APPEAL SUMMARY

Appeal ID: 20802	Project Address: 4110 SW Vesta St	
Hearing Date: 8/28/19	Appellant Name: Beate Ioanide-Culi	
Case No.: B-011	Appellant Phone: 5033802714	
Appeal Type: Building	Plans Examiner/Inspector: Robert Bigelow	
Project Type: residential	Stories: 2 Occupancy: R Construction Type: V-B	
Building/Business Name:	Fire Sprinklers: No	
Appeal Involves: Addition to an existing structure	LUR or Permit Application No.: 19-198305-RS	
Plan Submitted Option: pdf [File 1]	Proposed use: Residential

Appeal item 1

2 1-HOUR EXTERIOR WALL ASSEMBLY 2 SCALE: 1 1/2"=1'-0"

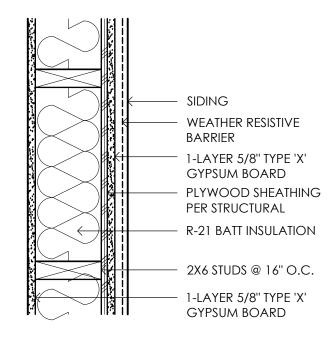
Code Section	ADU Program Guide
Requires	The ADU Program Guide requires that common areas be separated from the main house or ADU by 1-hr fire rated wall construction.
Proposed Design	A common deck and roof is proposed to connect the existing main house with the new Accessory Dwelling Unit. The existing wall of the main house at the deck area is required to be 1-HR rated. The existing wall is a 2x4 stud wall with 1/2" gypsum board at the interior face and plywood sheathing on the exterior. We propose to add 5/8" type 'x' gypsum board at the exterior face over the plywood but keep the 1/2" gypsum board at the interior. Detail 2 on Sheet 3 describes the assembly in detail and the Upper Floor Plan on Sheet 3 shows the location of the exterior wall tha requires the 1-hr rating. The existing door will be replaced with a 20-min rated door.
Reason for alternative	It is cost prohibitive to remove the existing 1/2" gypsum board at the interior face of the exterior wall that is required to be 1-hr rated and replace it with 5/8" type 'x' gypsum board. An existing bathroom and staircase are adjacent to the wall. Replacing the 1/2" gypsum board with 5/8" gypsum board would also reduce the existing staircase width which is at the minimum required for existing staircases. The proposed design to add 1 layer of 5/8" type 'x' gypsum board to the exterior face of the wall to bring the wall closer to the 1-hr rating is consistent with the ADU program guide provisions for allowing existing gypsum board to remain at existing walls.

Alternate 1 hour fire rated wall assembly to separate main house from common deck: Granted provided Type X gypsum sheathing extends to bottom of roof sheathing with fire blocking as required above the top plate.
